# Vieux Carré Commission Architecture Committee Meeting

Tuesday, November 11, 2025

**Materials & Connection Schedule**

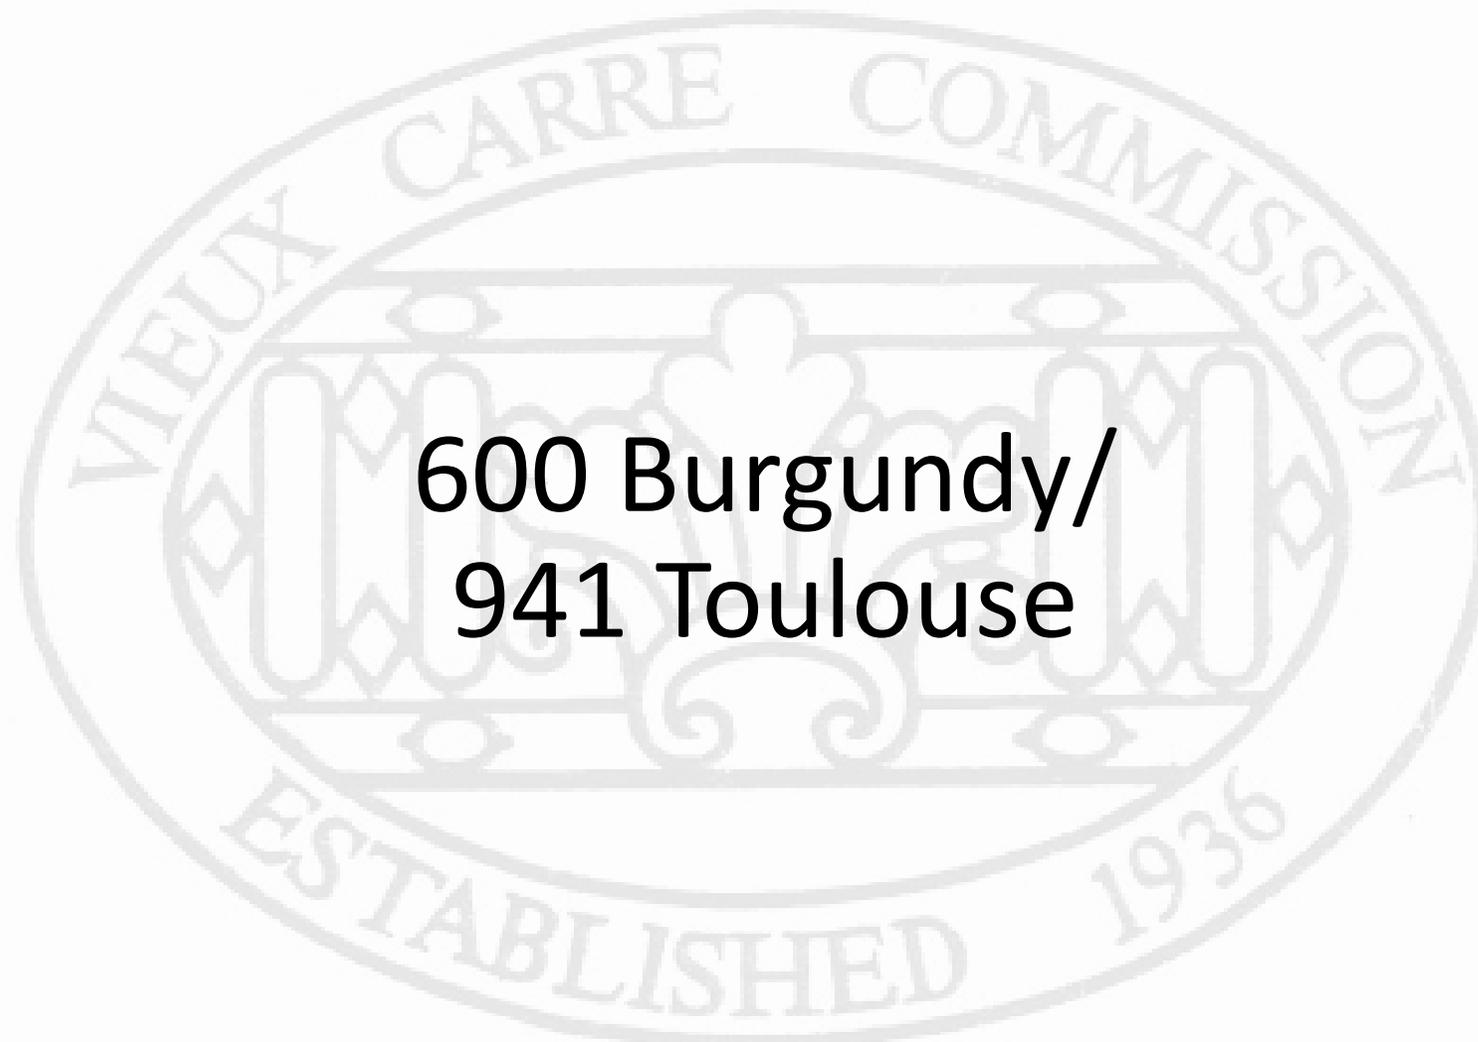
The applicant proposes to install a new natural slate roof, which is staff approvable in all aspects except rafter replacement and the proposed installation of copper parapet cap flashing. Approximately 25 2x6x12 rafters are called for replacement at the midspan of the roof, with Simpson Strong-Ties to be installed.
